NOTICE UNDER SECTION 96 OF ACT III OF 1901.

I beg to inform you that I intend building Tenements
on plot No. 42, 43 & 44

Street, Market — Quarter.

DRAWING NO: 173

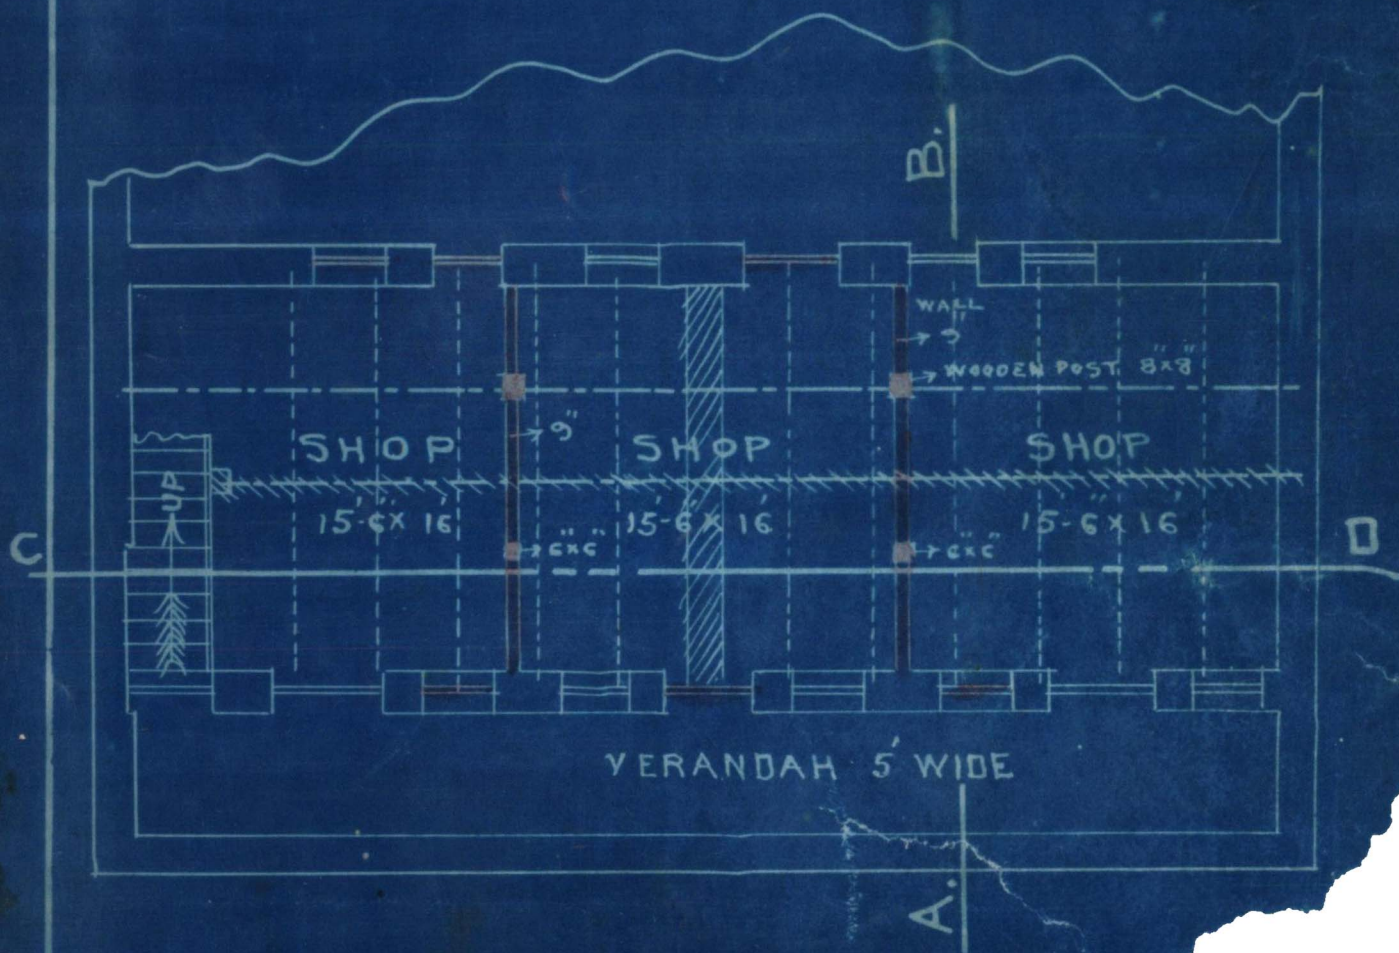
reference to his application dated 18th
received on 19th February M with plans for the
ing on Plot Nos: 42, 43 and 44 - C 6 Market quarte
amji Murarji and others are informed that one storey
be deleted from the plan. The return walls from the south
boundary to the verandah walls must be made pucca on the upper
floors. The plots must be amalgamated. The plans are returned
herewith for amendment.

Request that the plots require to be amalgamated.
The width of the street does not permit 4 stories
building as proposed.

I beg to report that the width of the
street does not allow 4 stories building
on these plots. Plots should be amalgamated
before any building is built. Request made

My trust be deleted from the plan
walls from the South boundary to the
the walls must be amalgamated
on the upper floor &
must be amalgamated.
